PROJECT REVIEW REPORT

Project ID	0960
Project Name	'Lumin/Eucapine Uruguay' Forest Plantations on degraded grasslands under extensive grazing
Review Type	VCS Verification Approval; CCB validation and verification approval
Program(s)	VCS Program and CCB Program
Verification Period	VCS: 08 April 2013 – 31 December 2020 CCB: 22 February 2006 - 31 December 2020
Project Proponent	LUMIN/EUCAPINE SRL
Methodology	AR-ACM0001: Afforestation and reforestation of degraded land — Version 5.2.0
VVB	SCS Global Services
Assessment Criteria	<i>VCS Standard, v4.1, CCB Program Rules, 3.1</i>
Date of First Issue	22 Dec 2022
Date of Second Issue	17 Aug 2023
Review Conclusion	Approved
Date of Final Issue	19 Oct 2023

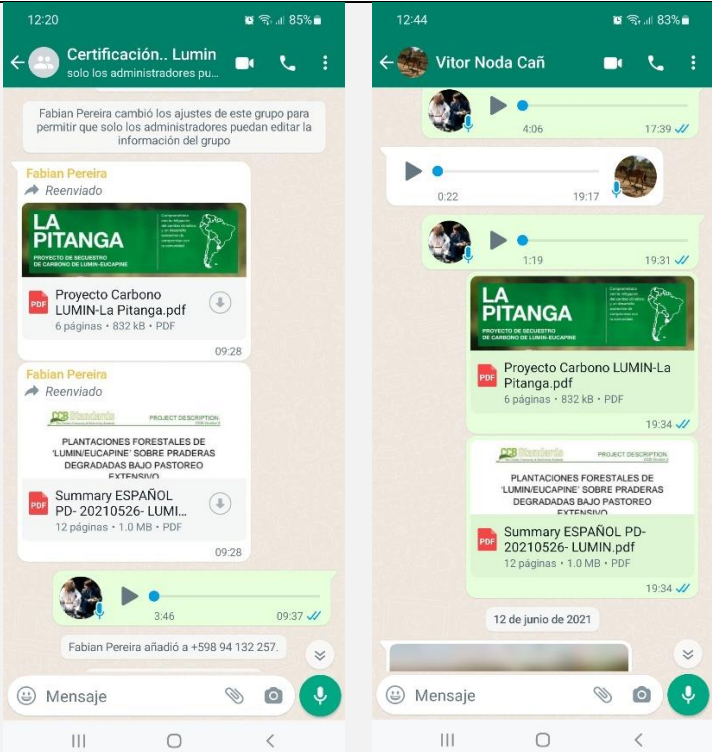
instances. <u>Required action</u> 1. The VVB must ensure the newly acquired or annexed properties are not added to the project area. The only permitted change to the project area are the mapping adjustments. <u>Program Rule(s)</u> <i>VCS Standard, v4.3, Section 3.6.5; VCS Program Definitions, v4.3</i> <u>Background</u> <i>VCS Standard, v4.3, Section 3.6.5 : Inclusion of further project activity instances subsequent to initial validation of a non-grouped project is not permitted (see Sections 3.6.10 – 3.6.17 for information on grouped projects).</i> <i>VCS Program Definitions, v4.3 : Project activity instance - A particular set of implemented technologies and/or measures that constitute the minimum unit of activity necessary to comply with the criteria and procedures applicable to the project activity under the methodology applied to the project</i> Round 2 <u>VVB Response</u> The project has removed all new project instances either annexed into existing properties or based in new properties. The only changes made to the project area were mapping adjustments based upon new high-resolution imagery. The audit team re-calculated areas and inspected the project's updated shapefile with high resolution imagery. The audit team also checked that the updated areas had been accounted for in the project's various calculations and in section 3.2.3 of the MR.

Section 3.3 of the verification report has been updated to accurately document the evaluation of these mapping adjustments on the project area.	
		<u>Verra Response</u> The newly acquired or annexed properties were removed from the project area and the only adjustment was to reduce the project area based on new high-resolution imagery that increases the accuracy and conservativeness of the ERRs.
